Appendix E

Appendix E.2
Water Quality Memo

Date: 11/17/24
Re: NWBPC DEIS – Response to Water Quality comments
From: Arcadis

Comments on the North/West Battery Park City Resiliency Project Draft Environmental Impact Statement (DEIS)

Figure 1 - CSOs Within Hudson River Park

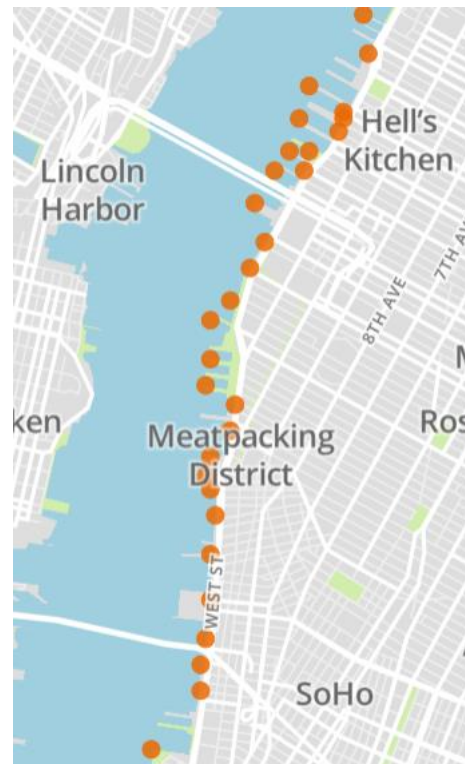
This memo responds to comments received on the North/West Battery Park City DEIS in regard to the project's potential for significant adverse impacts on the water quality of the Hudson River. Please find attached the full comment letters from those listed below (note these also include comments unrelated to water quality). Manhattan Community Board 1's comment letter raised similar concerns regarding discharge to CSO outfall NCM-073.

The DEIS's proposed new pump station includes plans for a sewer main to be installed below the Hudson River's surface under the Hudson River Park esplanade between BPC and Pier 25 and connected to an existing combined sewer outfall (CSO) in HRP's Estuarine Sanctuary – meaning any surface water collected by the BPC barrier system after a storm event would be pumped into this section of the Sanctuary. The area in question is a corner of bulkhead walls, which will make circulation difficult and any untreated surface water pumped into the area would not dissipate easily, potentially causing harm to the Sanctuary.

Figure 3.7-3 in the DEIS indicates that this CSO NMN-073 is currently connected to the opposite side of Route 9A with minimal stormwater input from Battery Park City. Therefore, the proposed plan to pump untreated stormwater from Battery Park City to this CSO will result in an increase in water pollution in the estuarine sanctuary. These concerns were brought to the team's attention during their June 11 briefing with the Advisory Council, **yet the DEIS fails to acknowledge or address the potential impacts of this element of the revised resiliency plan.**

Second, the Proposed Project includes a pump station located at Stuyvesant Plaza. The underground pump station is comprised of pumps and a receiving “wet well.” When the existing combined sewer network flows into the wet well, the surface elevation in the wet well increases, and the pumps are triggered to turn on and the water is discharged through pipes to the downstream side of the tide gate before discharging through the existing CSO outfall NCM-073

During the design storm, this pump station would draw water from the existing combined sewer and pump it to the downstream side of the tide gate before discharging through the existing CSO outfall NCM-073. To manage flooding across a larger area, additional piping is proposed to connect regulators associated with outfalls NCM-073 and NCM-072. Additionally, as the sanitary connection to the interceptor would be closed during the storm, the existing sanitary connection along Vesey Street would be redirected to the existing combined sewer system and connected hydraulically to the pump station to prevent sanitary backups into the buildings and streets within the northern Project Area. The connection to NCM-072 and the redirection of the sanitary connection along Vesey Street would redirect approximately 2 million gallons of combined sanitary and stormwater flows to CSO outfall NCM-073 during these infrequent, extreme coastal storm events.

Based on the overall pollution load reduction that would result from the Proposed Project, the addition of approximately 2 million gallons of combined sanitary and stormwater flow at NM-073 during extreme storm conditions would not result in a significant water quality impact.

Attachment 1

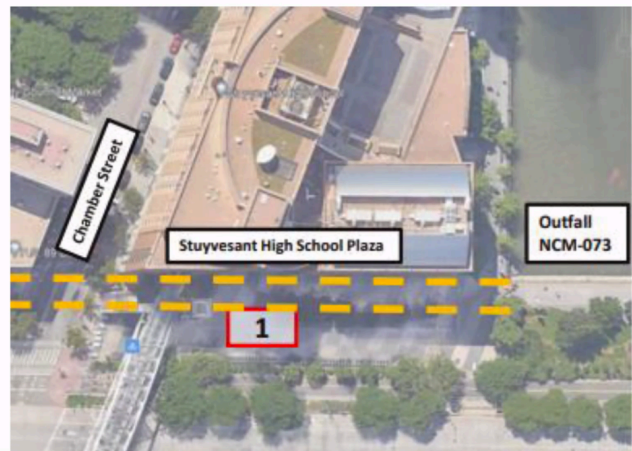
At the June 11th Advisory Committee meeting, the BPC team stated that the design of the pumping station was not complete and that the design of this element would lag other aspects of the resiliency plan and would be presented to the public later (see Attachment 1). **Have the impacts of this pumping station on the Hudson River Park Estuarine Sanctuary been studied as part of the DEIS for the overall project? If not, any separate assessment of the pumping station's impact outside the DEIS for this project would result in segmentation.**

The planned pumping station is rated at 60 million gallons/day. The SEQRA/CEQR Analysis that highlighted post-construction impacts presented at the public meeting on September 18th indicated that the effects of the proposed pumping station on water and sewer infrastructure had received a detailed analysis and there would be no significant impacts (see Attachment 2). Did that include the water quality impacts of pumping untreated surface water from BPC into the estuarine sanctuary? If so, the technical information that the North/West BPC Resiliency Project provided to the NYS Department of Environmental Conservation for their assessment and approval must be shared with the public.

What volume of water is expected to be pumped into the sanctuary, and for how long? How often is this activity expected to occur? During what times of the year will the pumping occur? How were the potential impacts on habitat and in-water recreational uses such as kayaking at Pier 26 or on the estuary restoration efforts the Hudson River Park Trust/Billion Oyster Project restoration program between Piers 26 and 34 studied?
